2.5 Modification 3 — surface facility heights at the Fairfield RWTP

2.6 Modification 4 — water recycling plant sewer connection line

2.7 Modification 5 — Woodville reservoir storage tank

2.8 Modification 6 — Rosehill reservoir storage tanks

Figure 2-7 Proposed location of sewer connection from the Fairfield RWTP

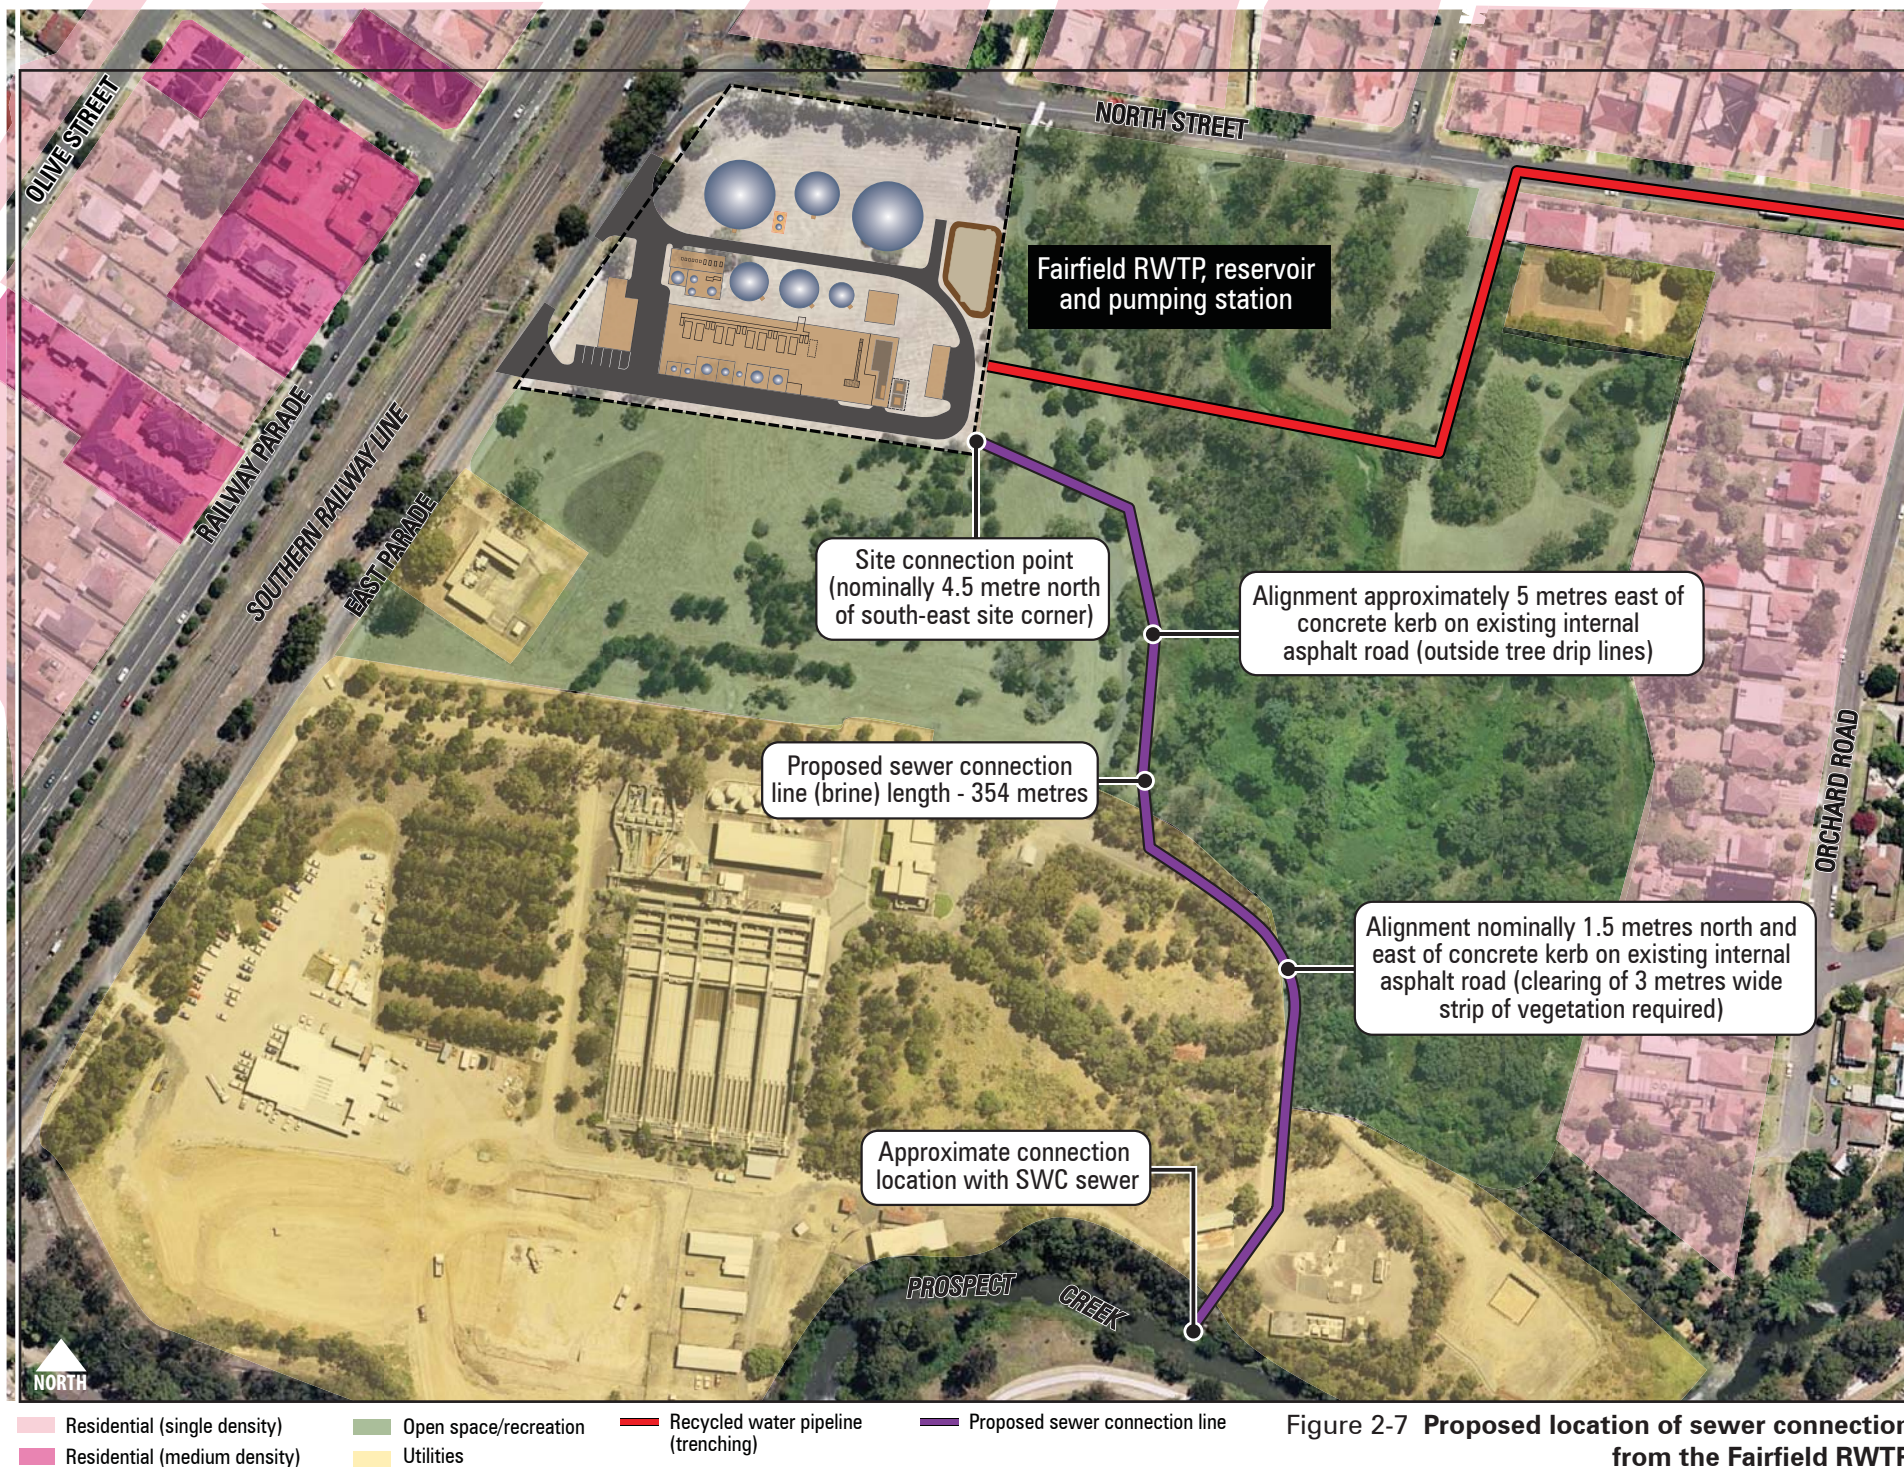
The description of a sewer pipeline ('brine line') to connect the Fairfield RWTP to a suitable location on the existing sewer system was in the approved Project EA but its route was not detailed. This modification outlines the proposed alignment of this connection line (refer Figure 2-6). As described in the approved Project EA, the waste stream from the Fairfield RWTP will be discharged to the Malabar sewerage system via a connection to the local sewer system, under a trade waste agreement to be issued by SWC. The trade waste agreement is being negotiated between SWC and Veolia.

The proposed pipeline would consist of approximately 354 m of sewer pipeline. A site connection point to the Fairfield RWTP would be made within the south-east corner of the Fairfield RWTP (refer Photo 2-9) before traversing east for approximately 40 m to an internal road (Symons Street). The pipeline would then traverse south, generally following the alignment of Symons Street to the Fairfield SSTP site. The pipeline would generally be constructed at an off-set distance of approximately 3–5 m from the access track (refer Figure 2-7). It would then connect with the existing SWC sewer line to complete the connection with the Fairfield RWTP.

Figure 2-9 Revised layout of the Woodville reservoir site

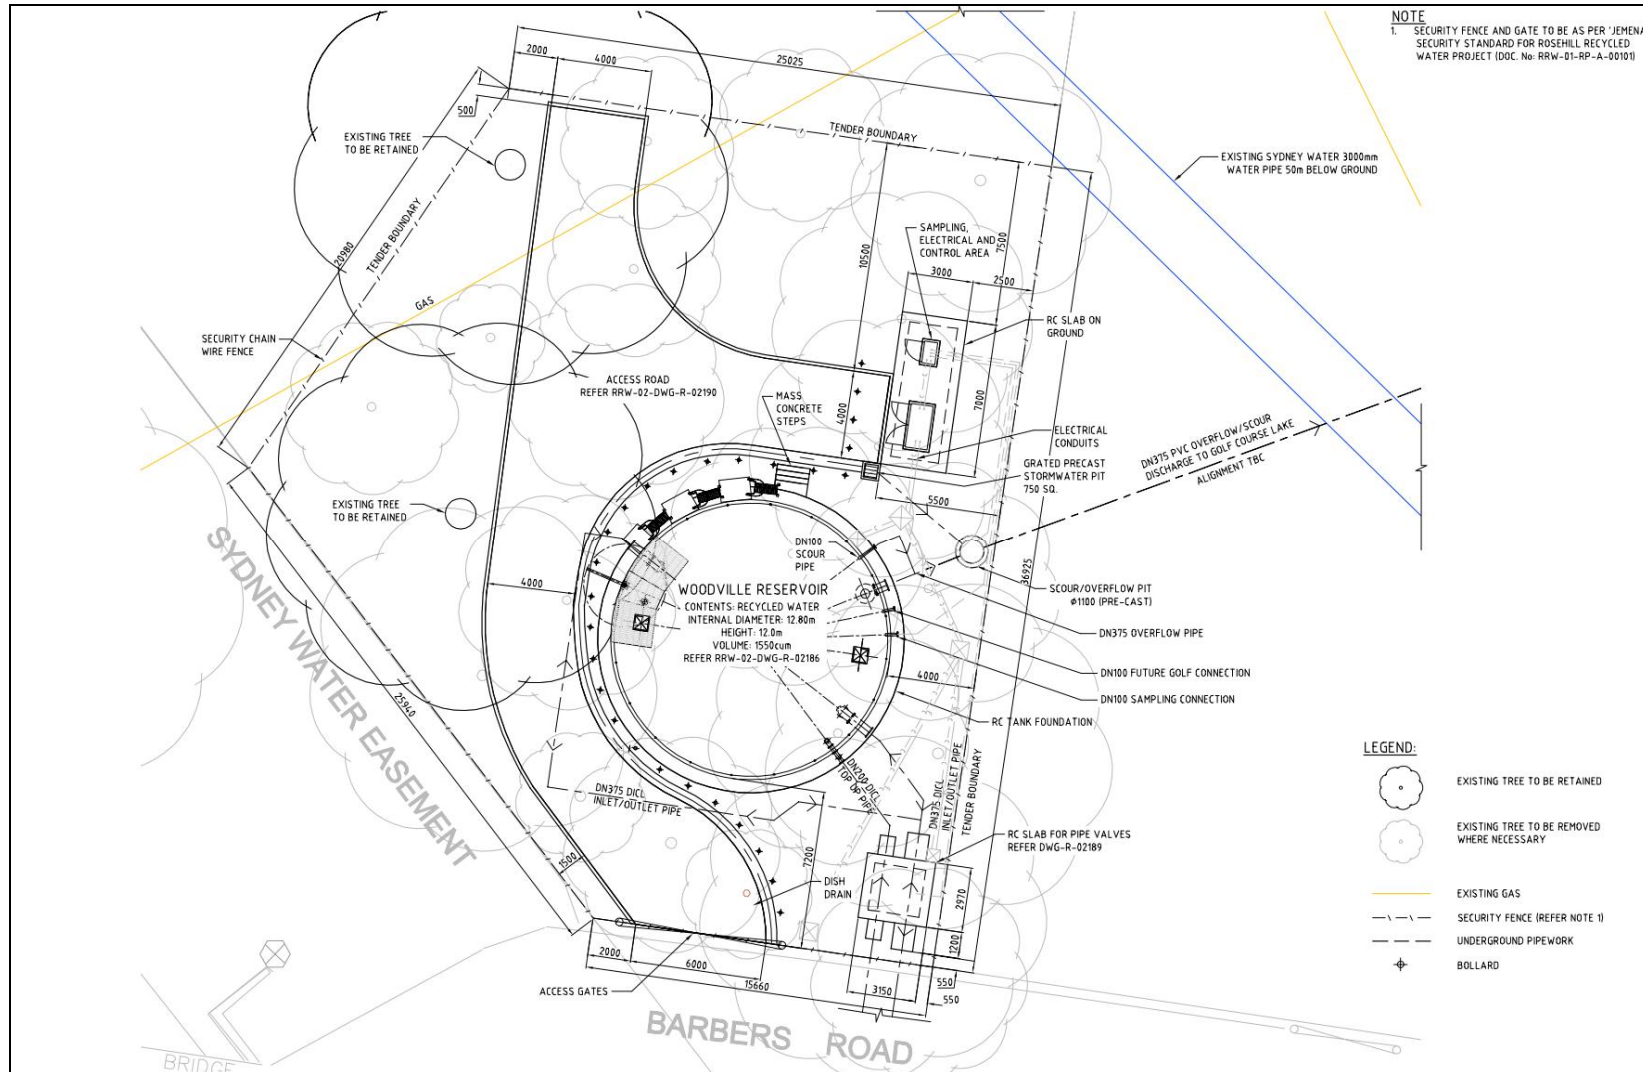
This modification reduces the number of trees that would be required to be removed as part of constructing the reservoir (refer Photo 2-9). To accommodate this, it is proposed to modify the size of the approved reservoir. The new reservoir would continue to comprise a single, cylindrical storage tank 12.8 m in diameter and 12 m high. It would no longer be supported by a structure above the ground, but rather constructed on the ground. The reservoir's storage capacity would be maintained as approximately 0.7 ML.

The reservoir would be located within the southern portion of the site with a setback of approximately 4 m from the southern boundary along Barbers Road (refer Figure 2-8 and Figure 2-9). A small concrete hardstand would also be constructed around the perimeter of the reservoir to allow vehicular access for maintenance and inspection.

Figure 2-11 Revised layout of the Rosehill reservoir site

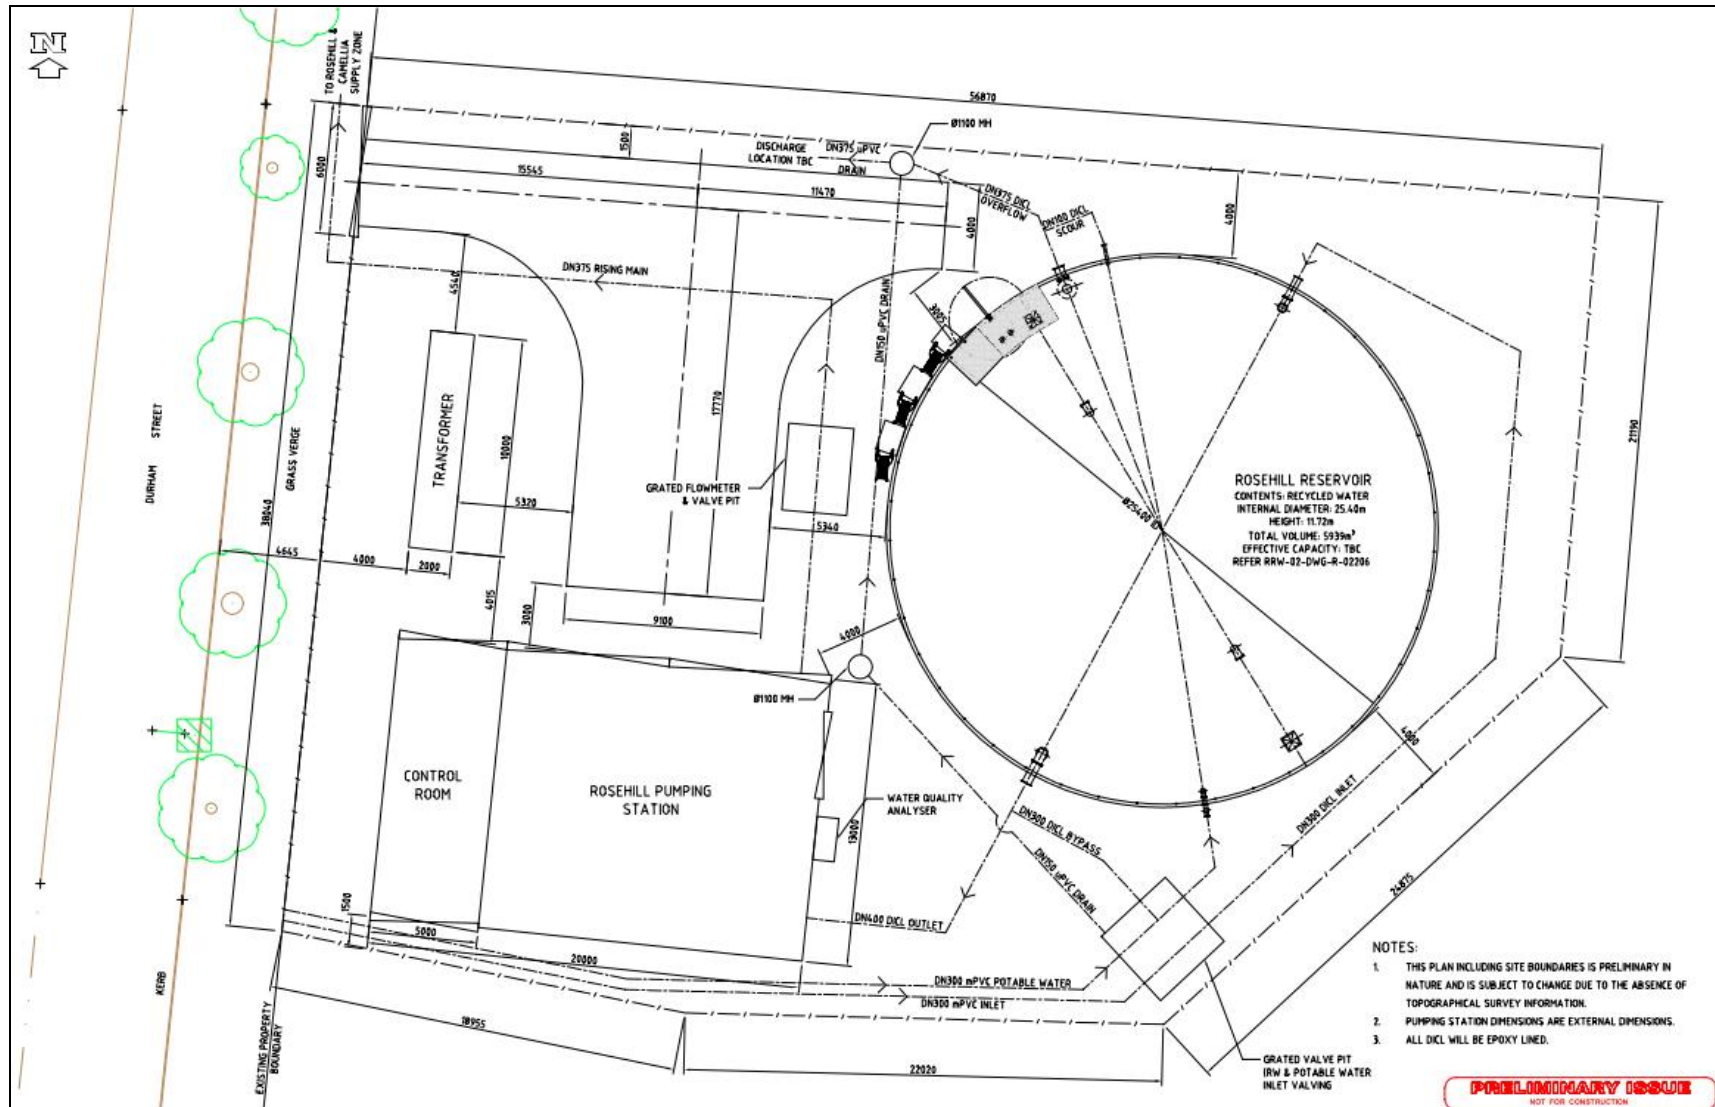
The proposed modification allows for fewer reservoirs present on the site. To accommodate this, it is proposed to replace the two proposed reservoirs with a single reservoir. The new reservoir would comprise a single, cylindrical storage tank with a diameter of 25.4 m and 11.72 m high. It would be located within the southern portion of the site with a setback of approximately 26 m from the western boundary along Durham Street (refer to Figure 2-11). The new reservoir would have a storage capacity of approximately 6ML.
